## Instrumentation for 40 mm Long Magnets

After some discussion among Wayne Koska, John Tompkins, Arnaud Devred, Jay Jayakumar, and myself, we have agreed that the following set of instrumentation will be put on the long 40 mm magnets built at Fermilab.

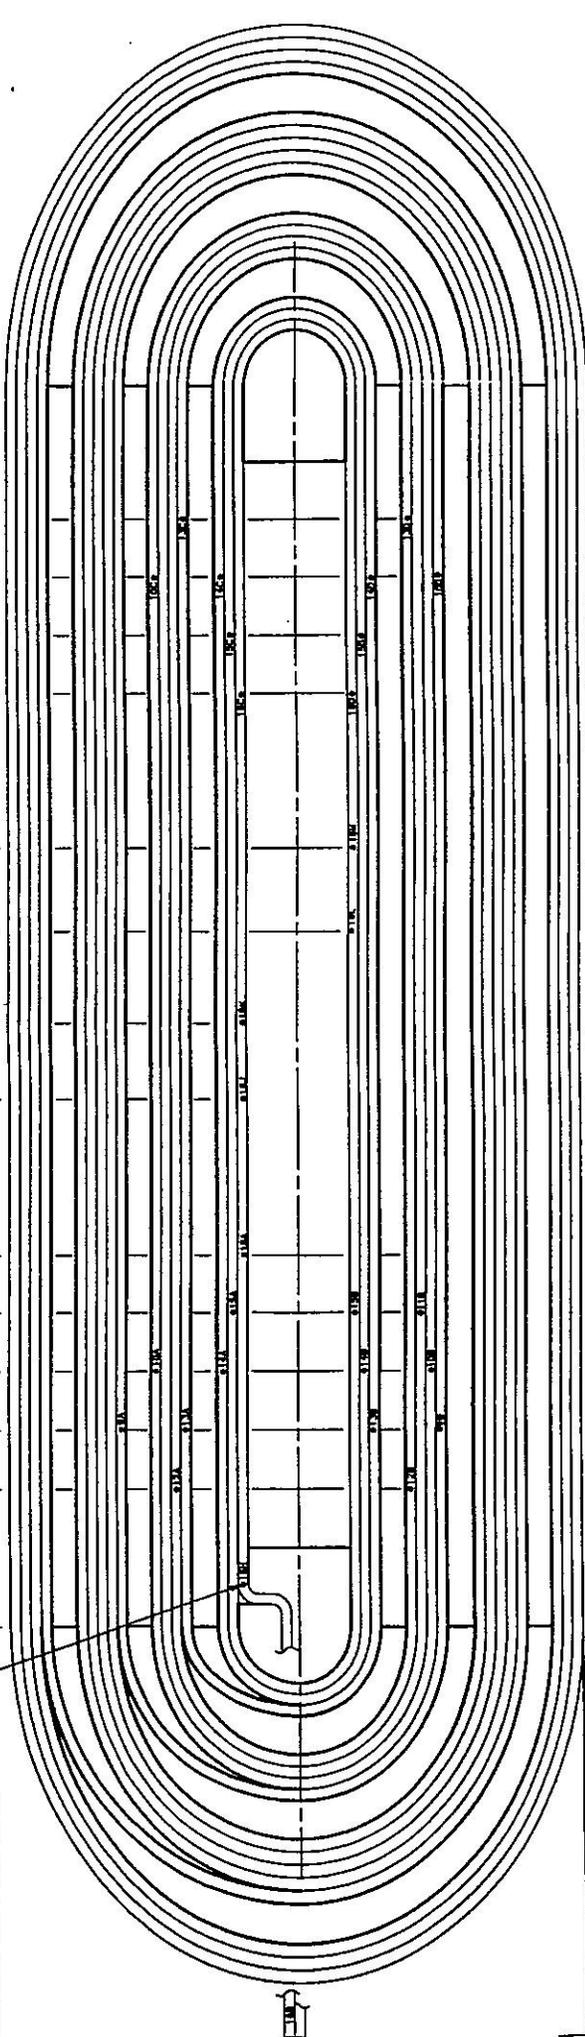
Figure 1 (from drawing #102-MC-263900) shows the voltage tap arrangement. The taps in the middle of the pole turn (16J, 16K, 16L, 16M) will be put only on DC0304. John Tompkins has requested that the drawing be revised to show explicitly the distance between the end of the coil straight section and the tap 16H and the corresponding outer coil tap 20A.
